FIELD INSPECTION

Project Name:	Mountain Valley Pipeline	Inspector:	Matthew Grant
Inspection Date:	Wednesday, June 12, 2019	Project Contact:	Brian Clauto
Spread: Pittsylvania County AR32 MP269-269	Spread I	Weather (Wet/Dry/Rain):	Dry

FIELD INSPECTION PHOTO LOG

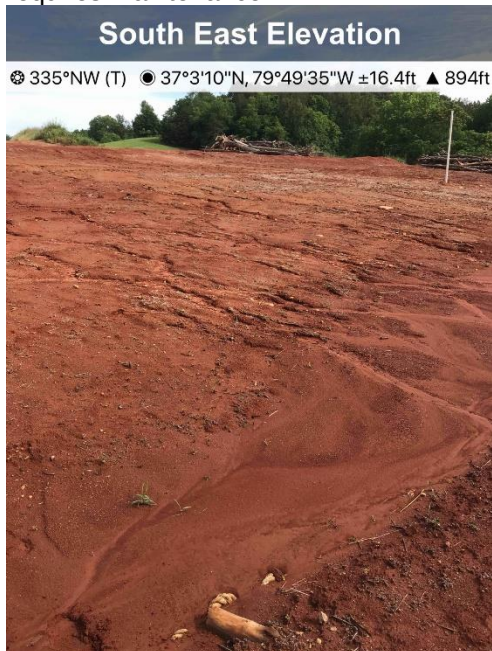
- Fig. 1 St1423+00 undermined P1 fence

- Fig. 2 St14219-14244+34 three sumps require maintenance

- Fig. 3 St14248+12 evidence of rill erosion and flow path requires maintenance

- Fig. 4 St14251+97 slip on slope

Recommended Corrective Action: Maintain all controls per the approved plan and specs and remove escaped sediment and bridge debris.

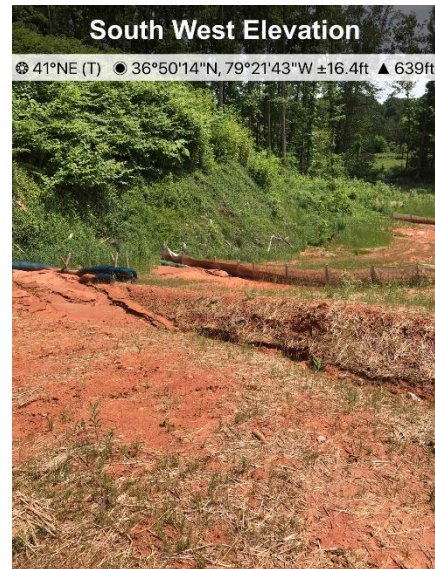
- Fig. 6 St15919+20 CFS and P1 requires maintenance

- Fig. 7 St15964+51-15947+75 escaped sediment in wetlands

- Fig. 8 St15964+00 rill erosion leading to sump
